AGREEMENTS REACHED ON MAY 8, 1998

EXPLANATION OF IMPACTS OF ATMOSPHERIC TANK VENT MANIFOLDS ON PHASE II EFFICIENCIES

Figure 1

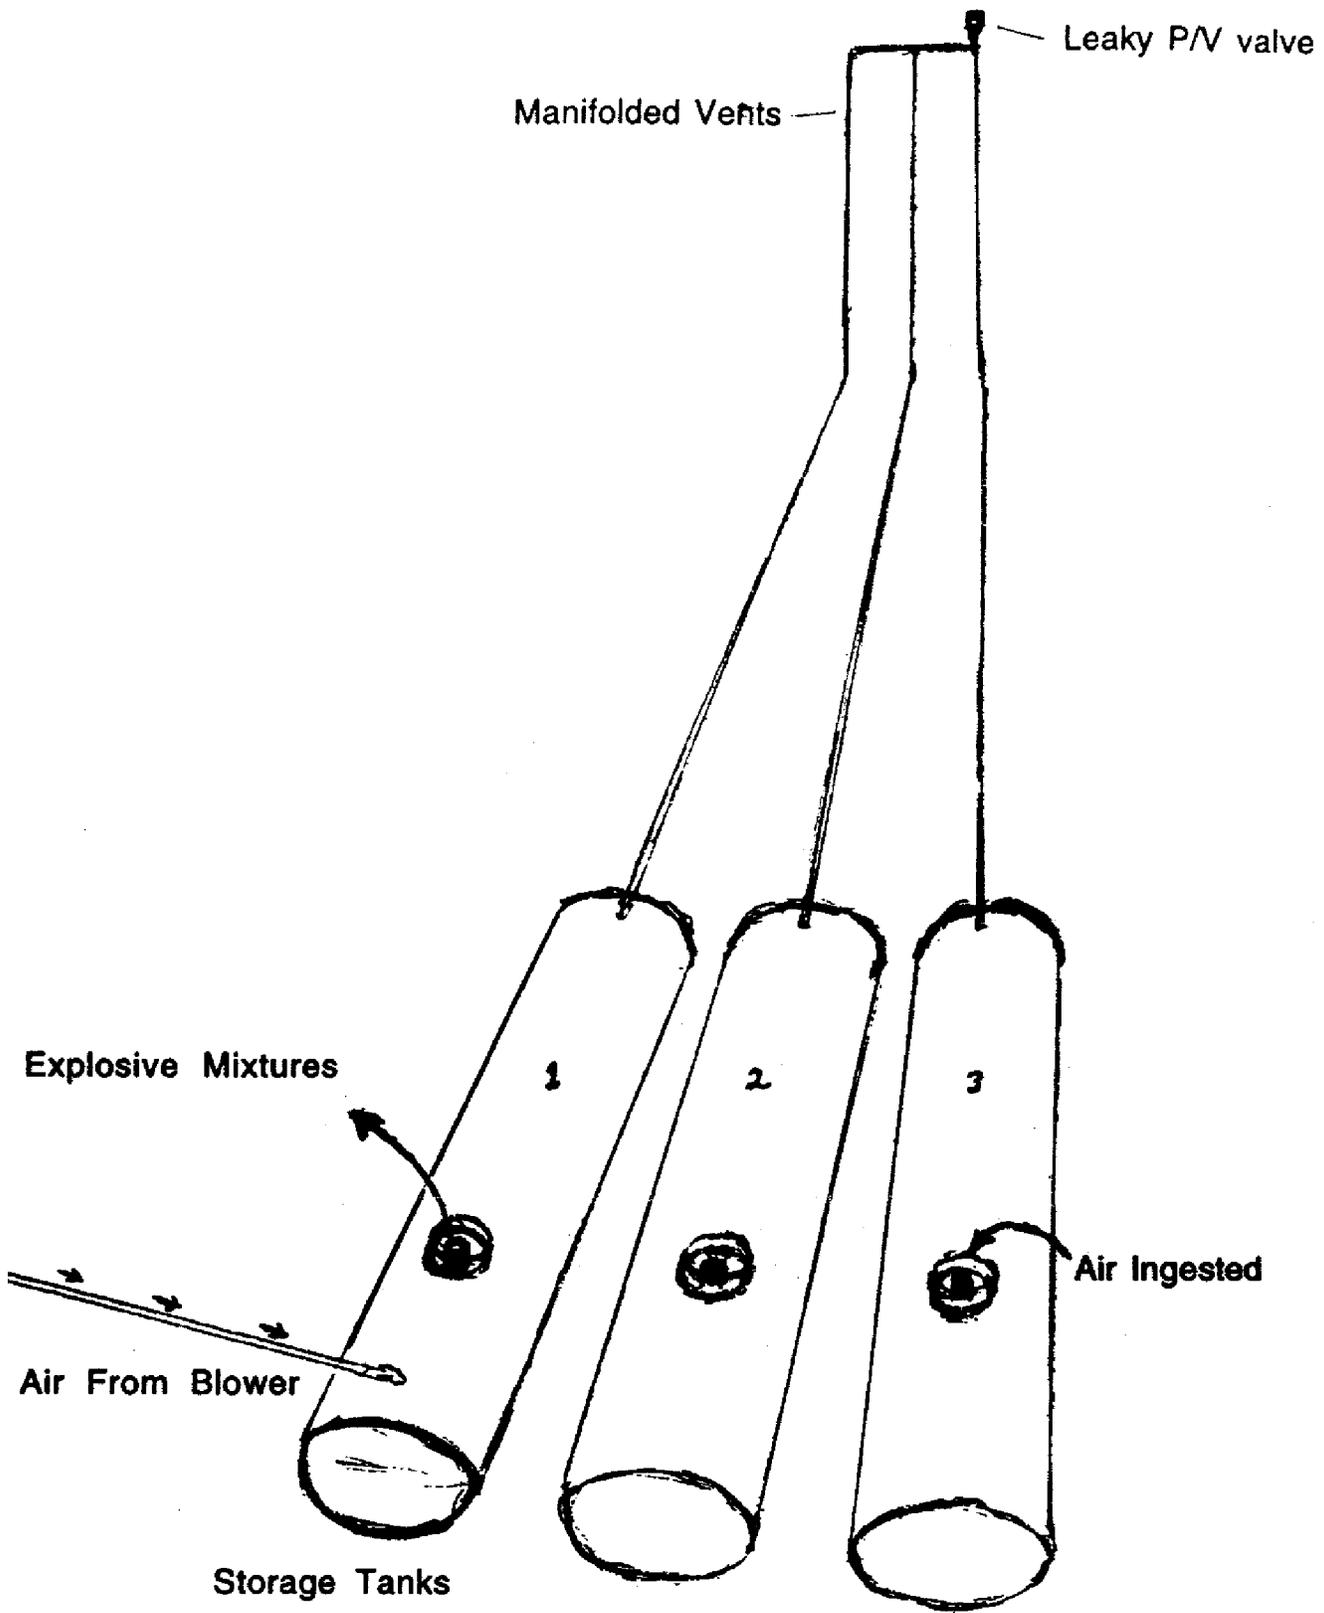
Attached is a drawing showing three underground tanks. In a worst case, gasoline vapors are sent to Tank 1. Meanwhile, liquid is being pumped out of Tank 3 while air is drawn in to replace the liquid through leaks in the Phase I fittings on Tank 3 and from a leaking pressure/vacuum (p/v) valve. The vapors sent to Tank No. 1 cannot return to replace the liquid in Tank 3 because of the ingestion of air. Instead, the vapors go out leaks in the Phase I fittings of Tank No. 1. In this worst case example, the potential Phase II efficiency is less than 30% because the vapors displaced from vehicle tanks with liquid from Tanks 2 and 3 never replace the liquid drawn from those tanks. Instead, all of those vapors go out the Phase I leaks of Tank 1. The air ingested into Tanks 2 and 3 causes vapor growth.

San Diego observed this problem using explosimeters at three Mobil sites with retrofit WayneVac systems. The Phase II efficiency couldn't be determined because it is relative to the sizes of the Phase I fitting and p/v valve leaks which were unknown, but the potential was there for substantial Phase II efficiency losses. ARB should prohibit the piping configuration shown in the drawing, especially given the system leakage rates reported by ARB and the districts.
